TECHNICAL SERVICE BULLETIN

Water Leak Onto Front Carpet From A-Pillar

22-2242

Ford 2015-2022 Mustang

Figure 2 - Example of failed A-pillar sticker seals

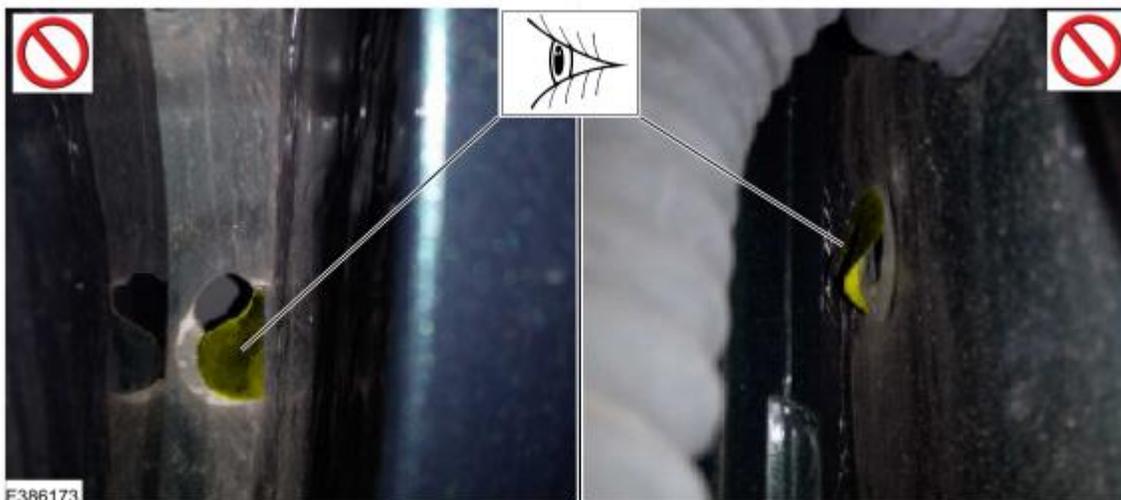
NOTE: The A-pillar body seals are an adhesive patch that seals a 19 mm (0.75 in.) diameter hole in the sheet metal. These seals must have complete adhesion around all edges. If any portion of the sealing surface is compromised, water entry into the cabin may result.

3. Are the body seals on both A-pillars completely sealed to the body? (Figure 2)

- (1). Yes - this article does not apply.
 - (2). No - proceed to Step 4.
4. Inspect the fender insulator to be sure it does not restrict access to the A-pillar body seal. If the fender insulator covers any portion of the A-pillar body seal, the foam fender insulator can be slightly indented to allow for unobstructed access to the seal.
 5. Apply paint-safe, protective tape to the door and fender edges.
 6. Use fingers and/or pliers to completely remove and discard the A-pillar body seal.

7. Use alcohol wipes to remove all remaining adhesive left by the discarded body seal.
8. Apply Motorcraft® Anti-Corrosion Coating to all exposed metal around the A-pillar body hole. Allow the Motorcraft® Anti-Corrosion Coating to dry following the instructions on the container.
9. Use a small paint brush to apply touch-up paint to the exterior surfaces that were previously coated with Motorcraft® Anti-Corrosion Coating. Allow paint time to dry following the instructions on the touch-up paint container.
10. Install and fully seat the new rubber body plug into the A-pillar body hole.
11. If the other A-pillar body seal requires repair, repeat Steps 4-10.
